Office Action Summary	Application No. 10/510,109	Applicant(s) GARCIA ET AL.	
	Examiner Jason J. Boeckmann	Art Unit 3752

DETAILED ACTION

Examiners marked up figure.

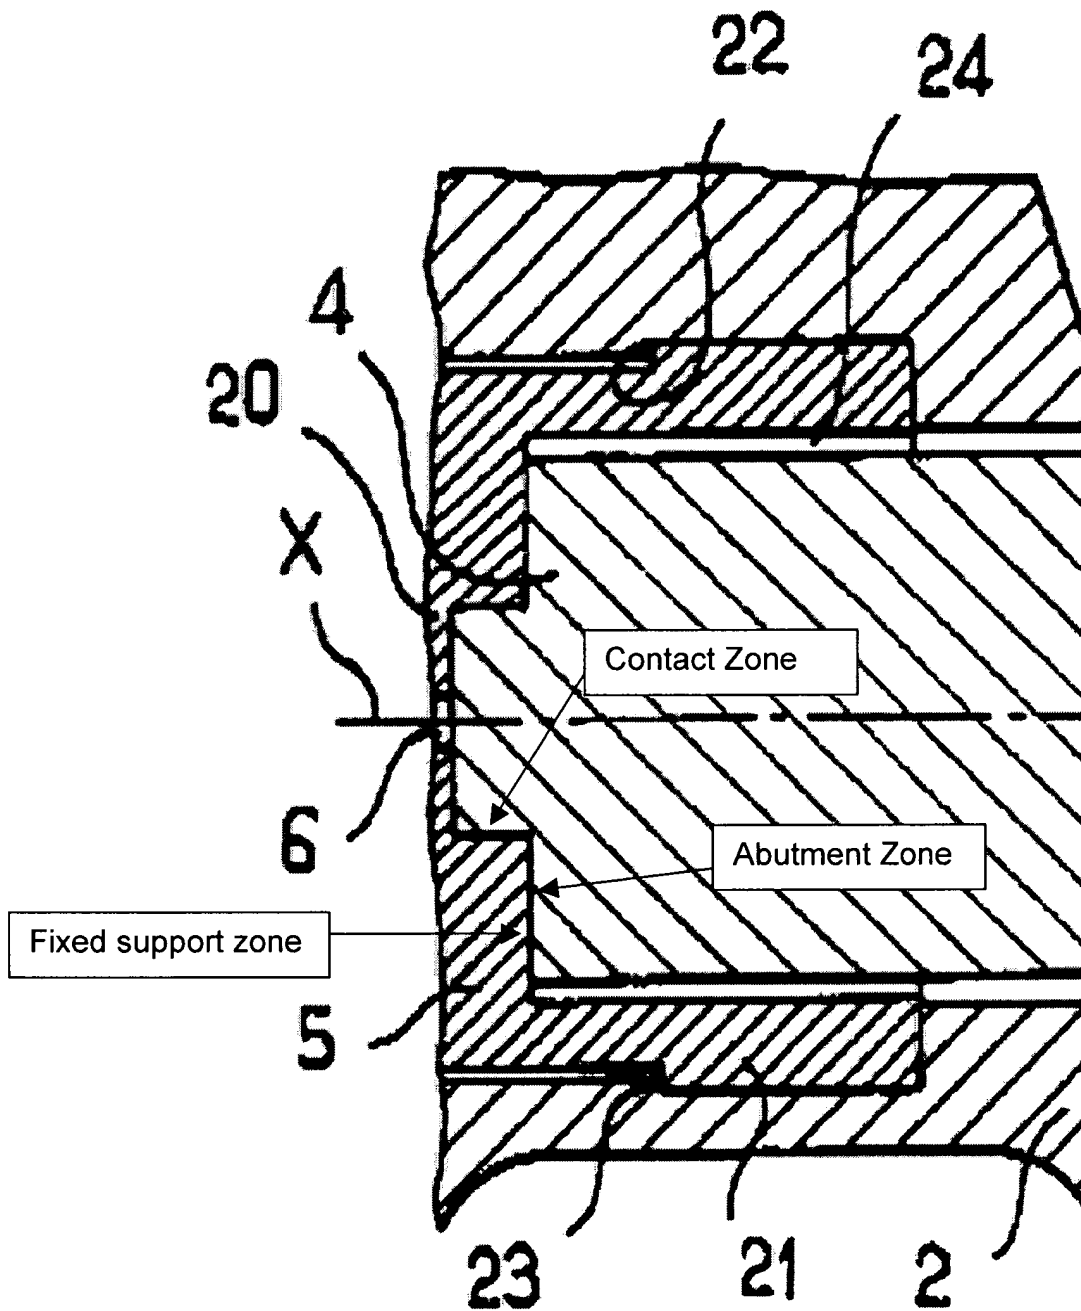
Lacout shows a dispenser head (1) comprising a connection sleeve (T), a dispenser orifice (6), a duct (10) connecting the connection sleeve (T) to the dispenser orifice (6) and a press surface (30). The head further comprising a shutter (4) that is housed at least in part in the duct (10), which is resiliently biased by spring means (13) towards the dispenser orifice (6). The shutter (4) includes a contact zone (located on the shutter, see marked up figure on page 7) that bears in a resilient leak tight manor against the dispensing orifice (6). The shutter being axially movable in such a means as to withdraw its contact zone form the dispensing orifice (6) creating an outlet passageway for the fluid when sufficient pressure is exerted on the press surface (30). The shutter (4) also includes at least one abutment zone (located on the shutter, see

marked up figure on page 7), located remote from the contact zone, that is resiliently biased by the spring means (13) against a fixed support zone (located on the end piece 5, see marked up figure on page 7). Lacout does not disclose that at least one of the dispenser orifice and the contact zone present a frustoconical configuration. However, Clanet et al shows a dispenser head (18) including a shutter (23) and a dispensing orifice (29), the shutter and the dispensing orifice both having frustoconical configurations (figure 4). It would have been obvious to one of ordinary skill in the art at the time of the applicant's invention, under the teachings of Clanet et al, to construct the dispensing orifice (6) and contact surface of Lacout, with a frustoconical configuration in order to create a better seal between them, for when the dispenser head is not in use.
